# SR 125/SR 32 FOCUS AREA ADVISORY COMMITTEE MEETING NOTES

## MEETING #3 NOTES

August 20, 2018

**Figure 32-2**  
**BIKE/PED CONNECTION FROM**  
**ROPE DRIVE**

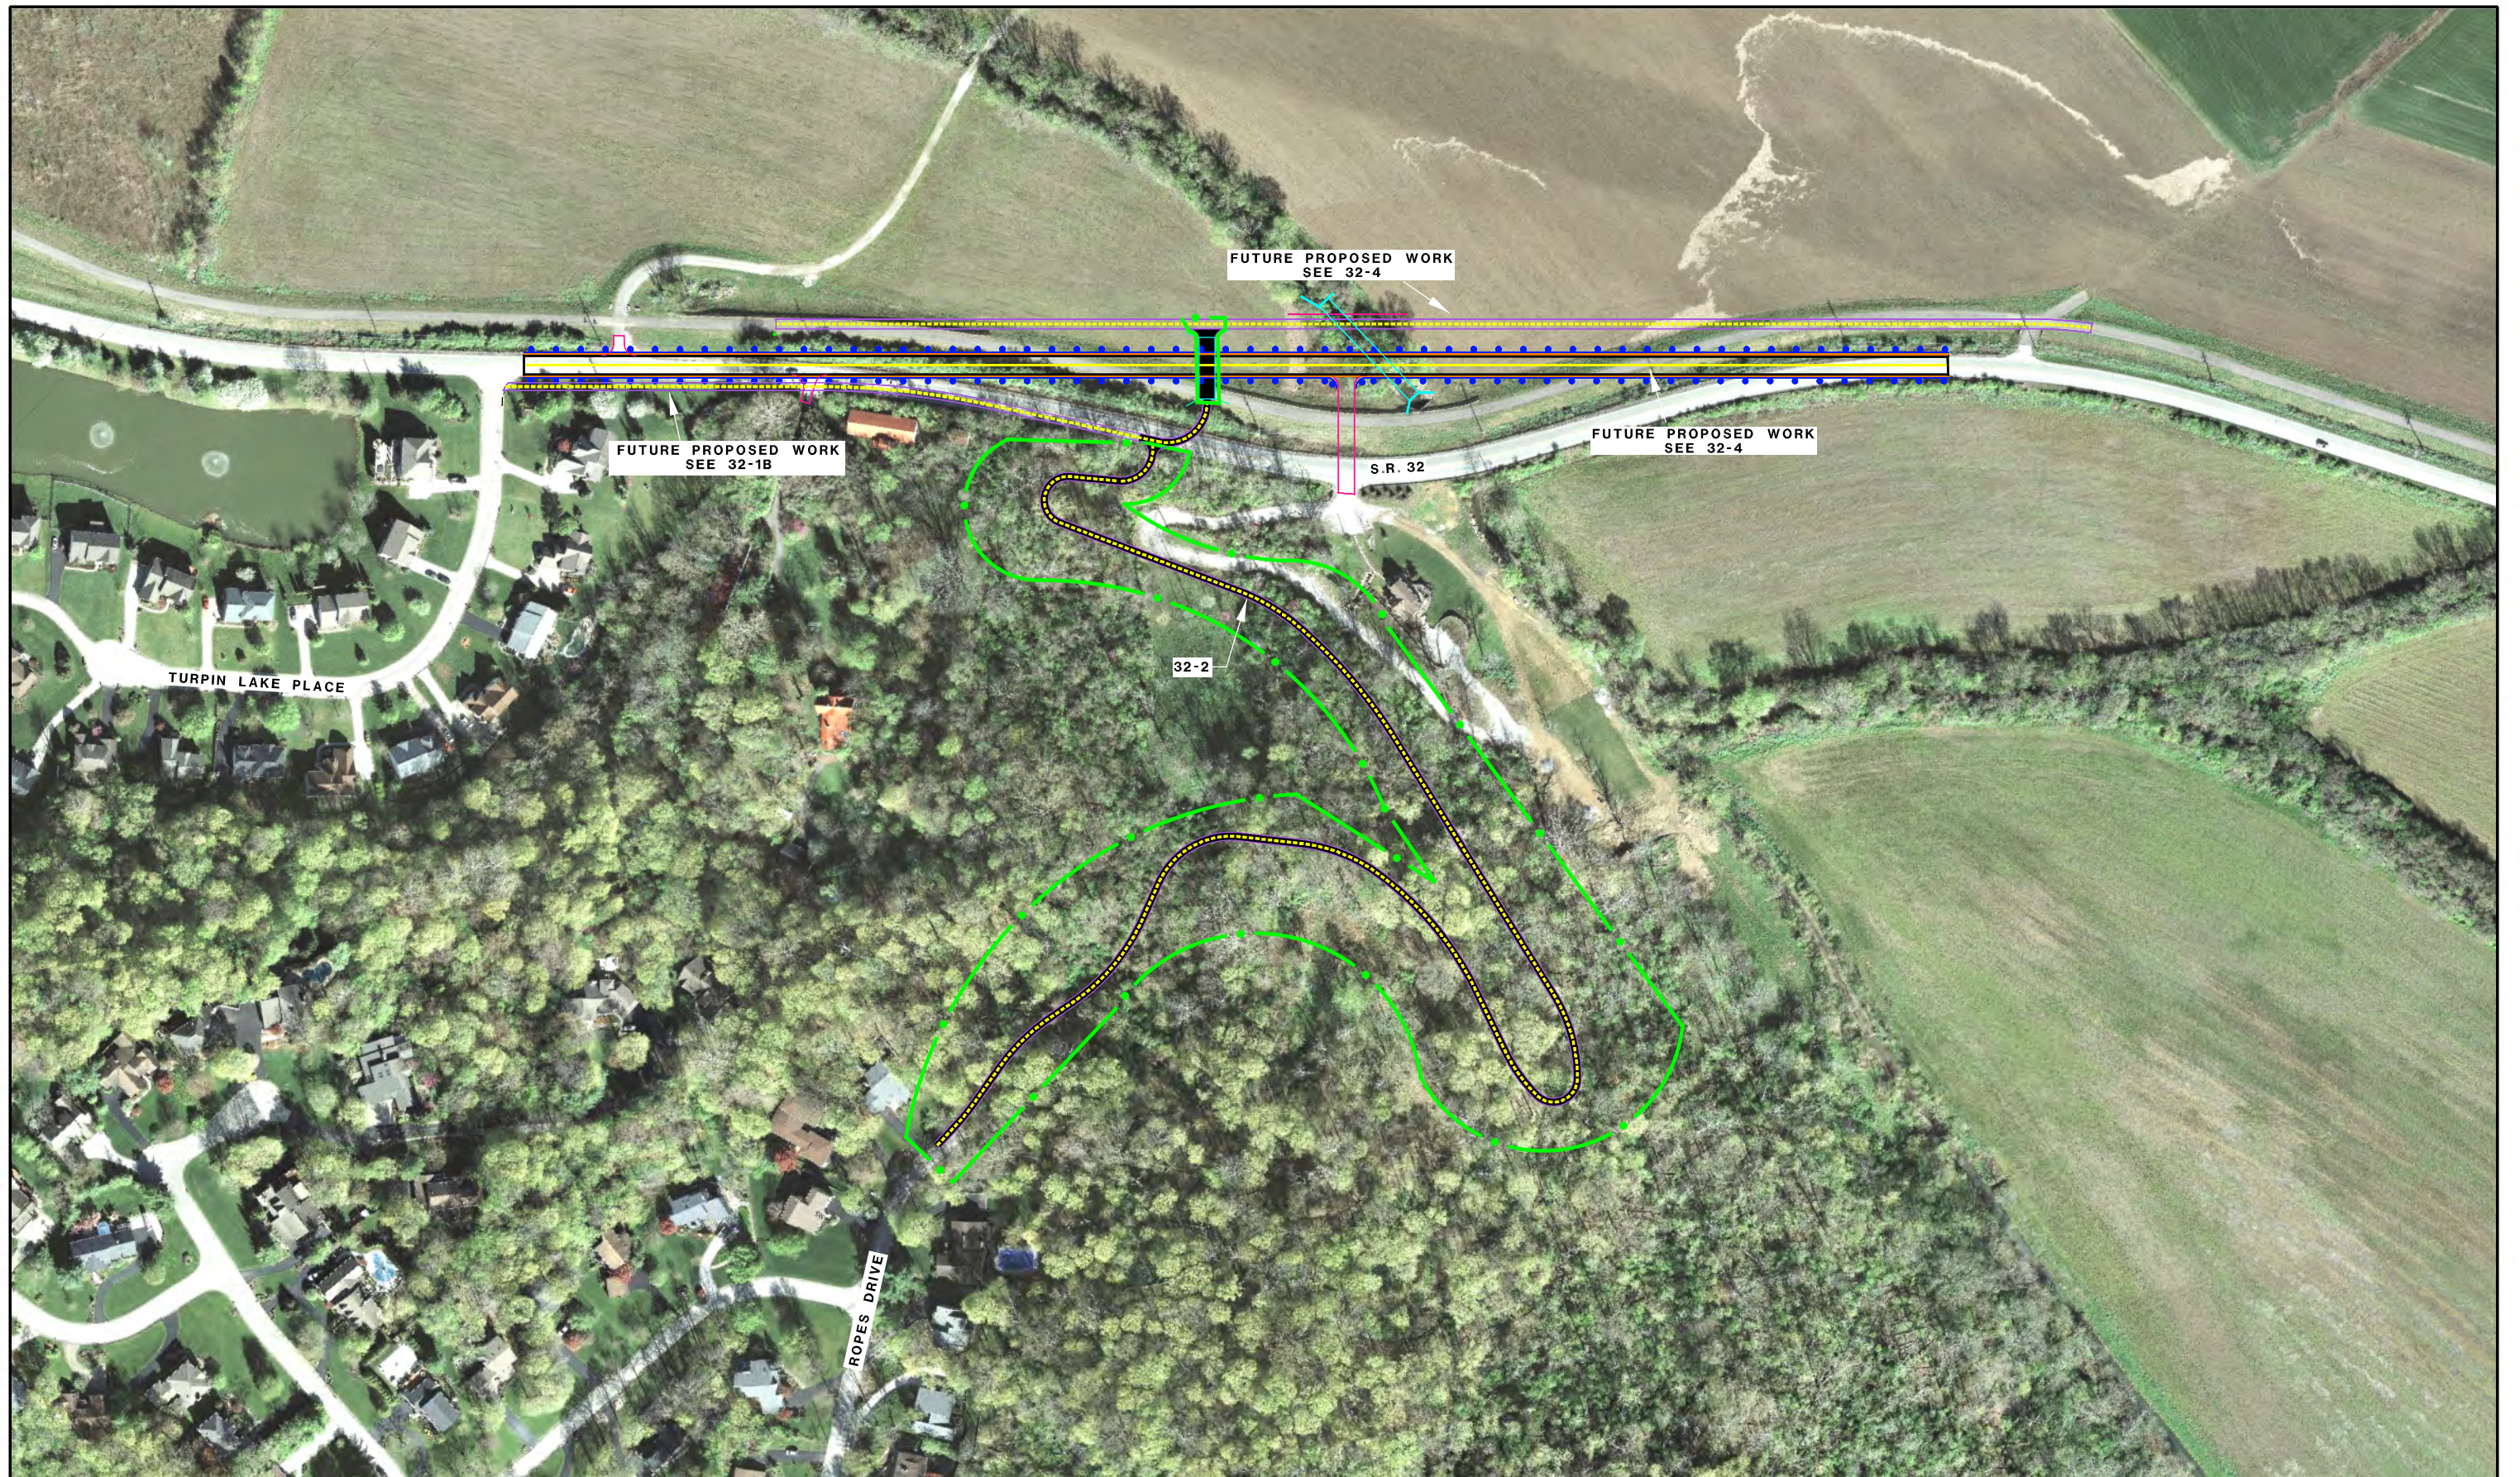
- The proposed concept travels along a very steep hill which could be challenging for bicyclists.
- There are very few houses at the end of Ropes Drive, which may facilitate neighborhood support for the project.
- This concept includes significant costs pertaining to cut and fill activities and retaining wall construction.
- ODOT will investigate a new alternative discussed at the meeting as concept 32-2a:  
*Connect Turpin Hills (end of Patterson Farms Lane) to the Little Miami Trail by utilizing the existing emergency access road connecting to Turpin lake Place. The final connection to the Little Miami Trail would be the same as 32-1a or 32-1b.*
